BIDDERS BULLETIN

PROJECT: Gateway Realty of North Platte
North Platte, Nebraska

BB-1

DATE ISSUED: February 7, 2014

DATE: February 4th, 2014
DRAWING: A601.1
FROM SHEET: A601

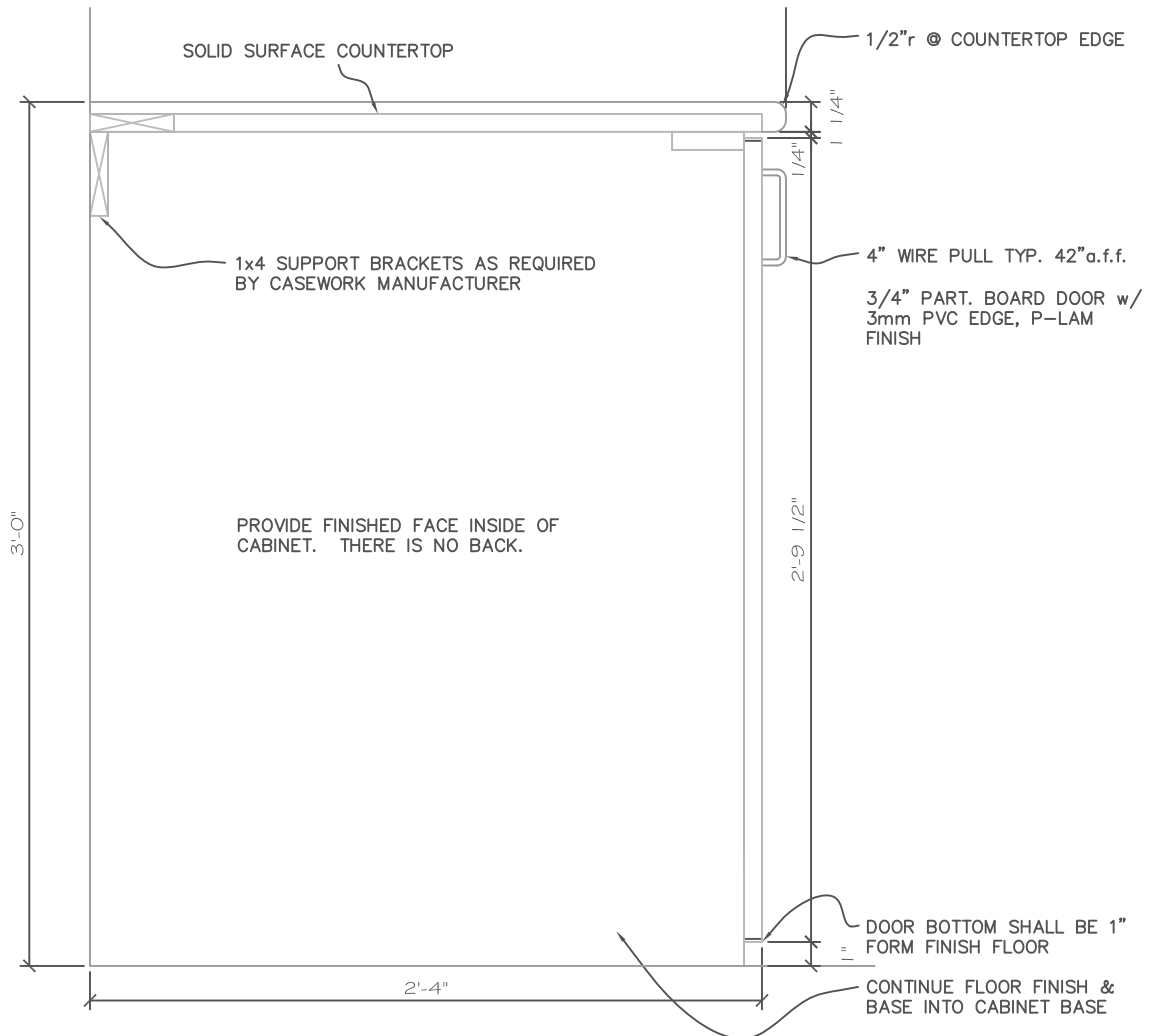
- The glass transaction counter top is to be a one piece of ¾" clear glass with eased/rounded & polished edges in lieu of 1" glass.
- Revised Coffee Bar elevation E8/A601. See attached drawing A601.1 & A602.1

A701R

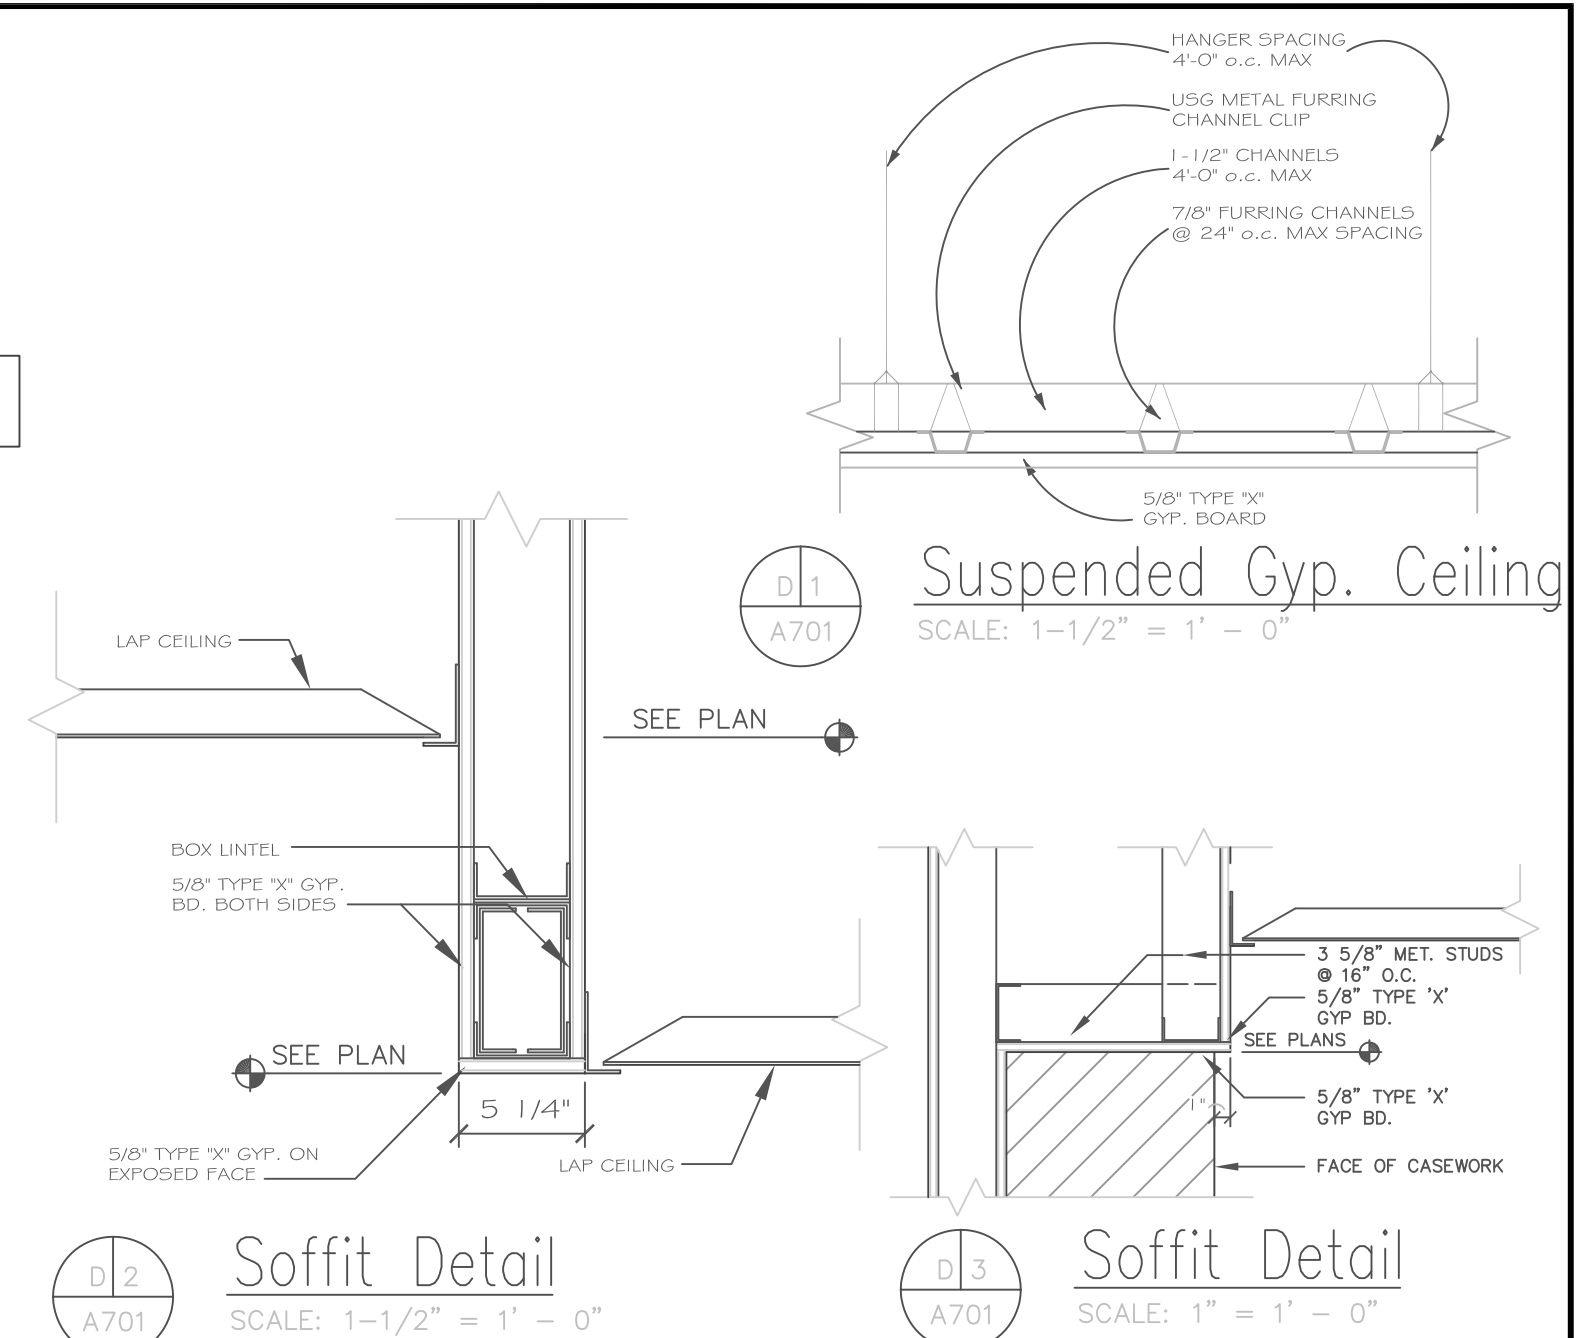
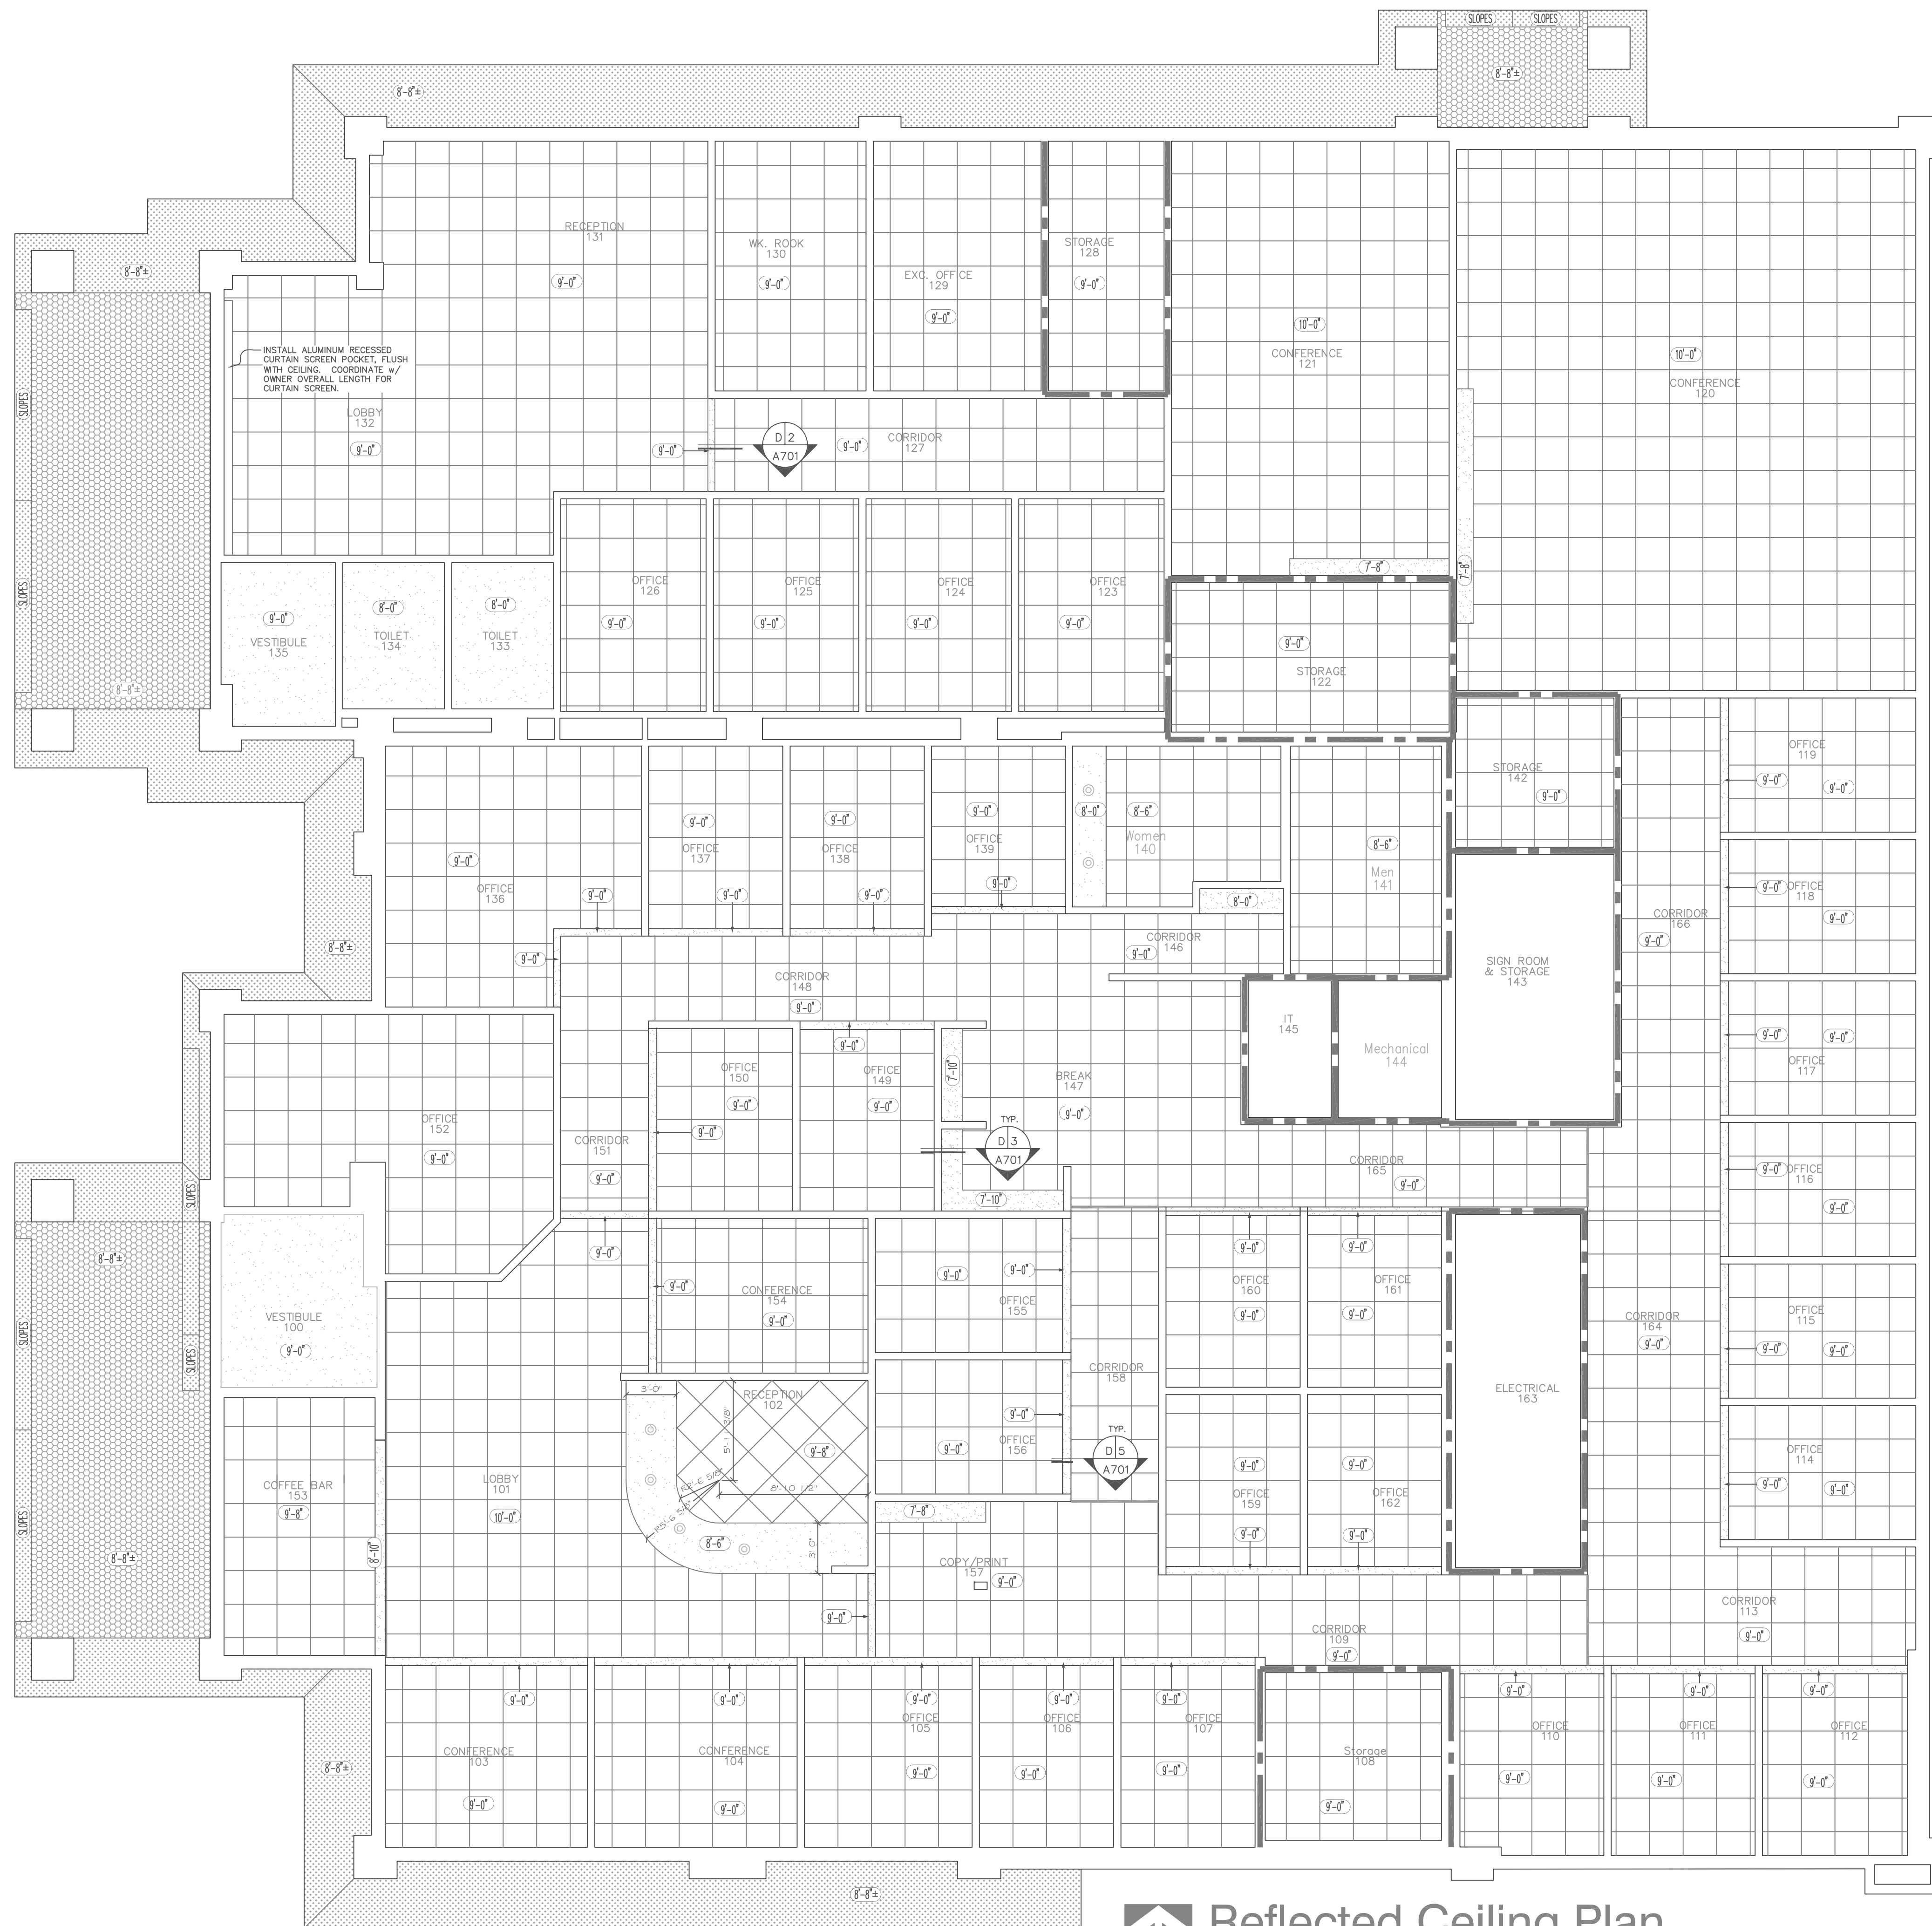
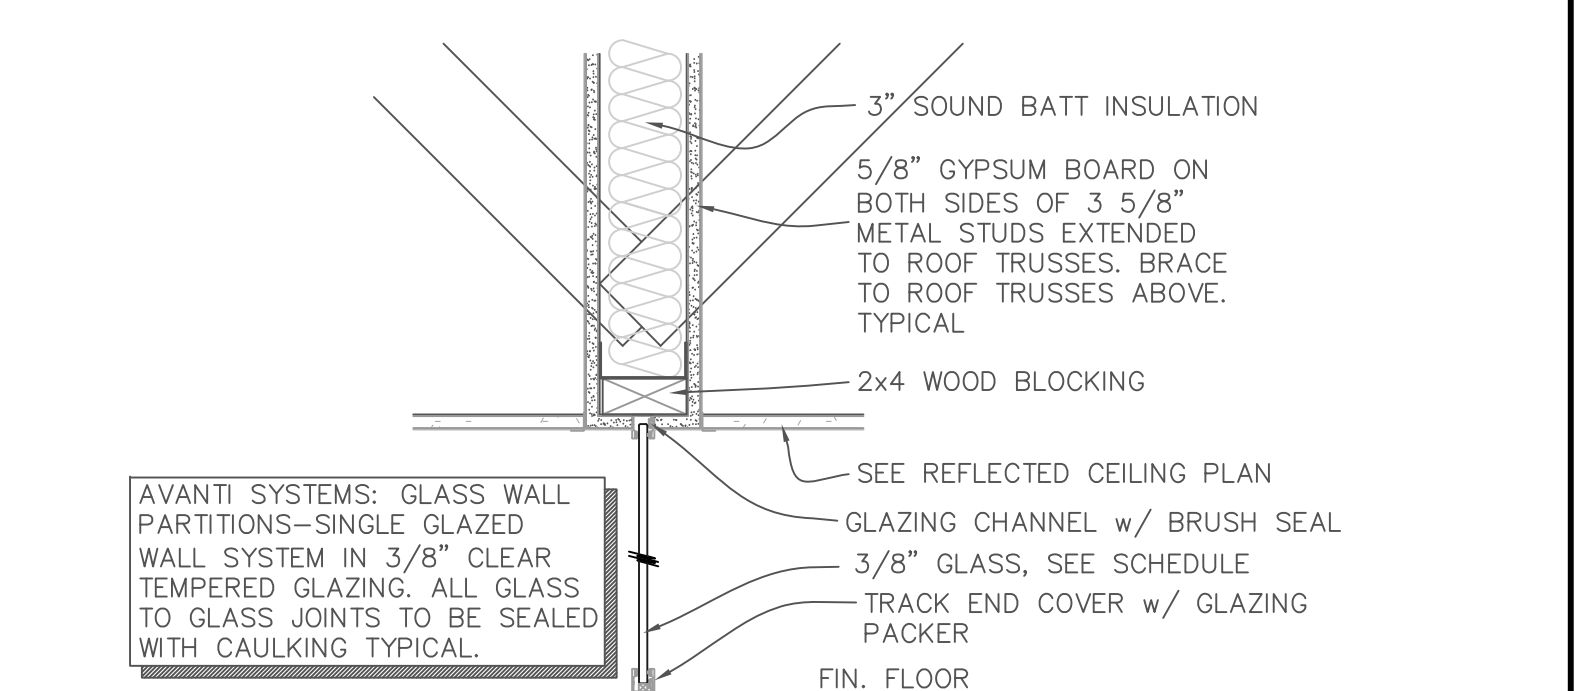
BB-1, ITEM #12: Replace Sheet A701 Reflected Ceiling Plan & Details, Changes include location of 1 hour fire rated wall.

DATE: February 4th, 2014
DRAWING: A801.1
FROM SHEET: A801

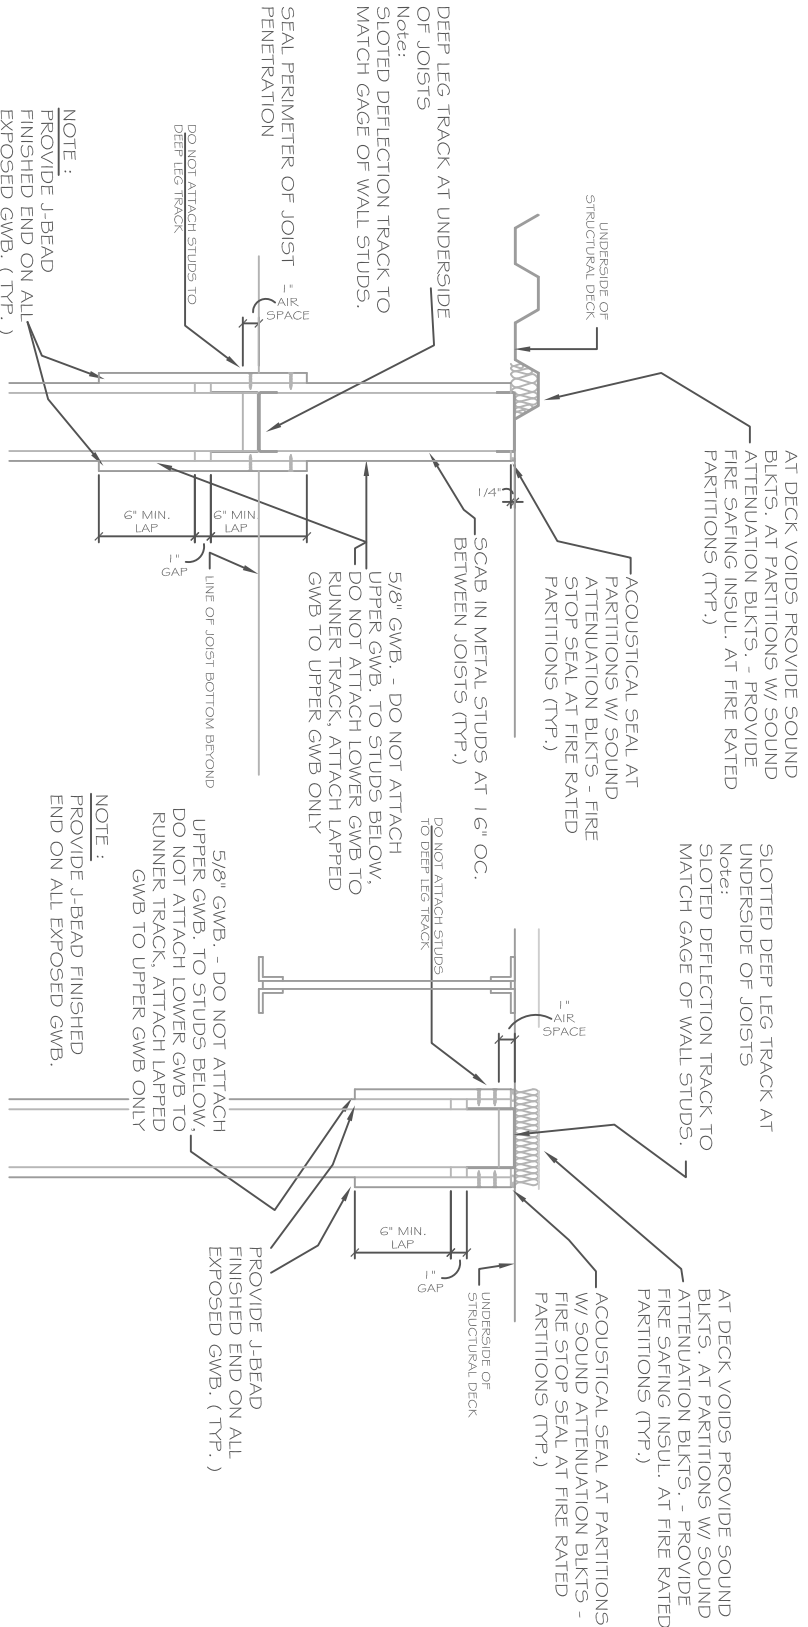
- Detail D6/A801 is not used
- Replace top of wall detail D1/A801. See attached detail on drawing sheet A801.1
- All framing of details on Sheet A801 is to be metal stud framing. Contractor's option to utilize wood studs as required for opening framing.
- At all fire rated walls use wood grained "Ready Frames" for the head and jamb framing with wood trim.
- Add corner stone veneer detail. See attached detail D17/A801 on drawing sheet A801.2
- Add Glass Partition & Door details. See attached details D18, D19 & D20/A801 on drawing sheet A801.2

DATE: February 4th, 2014
DRAWING: A801.4
FROM SHEET: A801

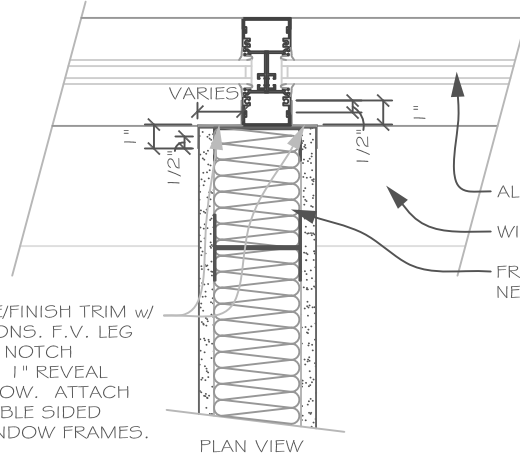
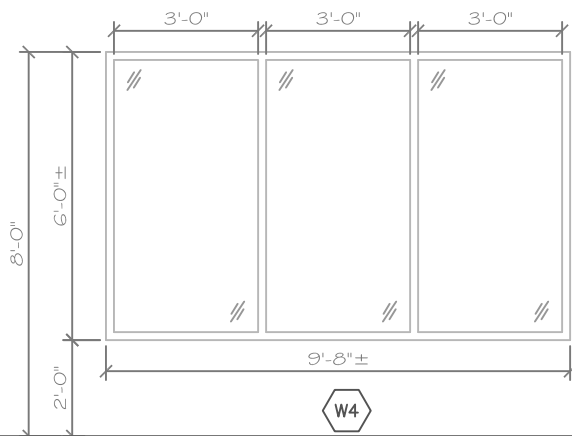
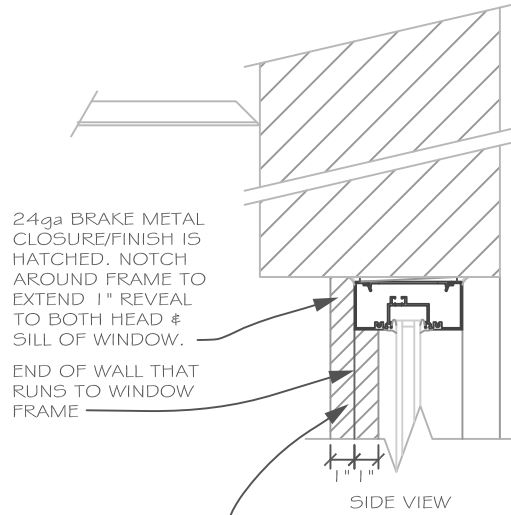
- Add detail where gyp wall meets aluminum window frame. See attached detail D21/A801 on drawing sheet A801.4
- Add window sill detail exterior walls. See attached detail D22/A801 on drawing sheet A801.5
- Add (2) Drop Boxes. See attached details D23/A801 on drawing sheet A801.6
- Add building expansion detail where new addition meets existing. See attached detail D24/A801 on drawing sheet A801.7
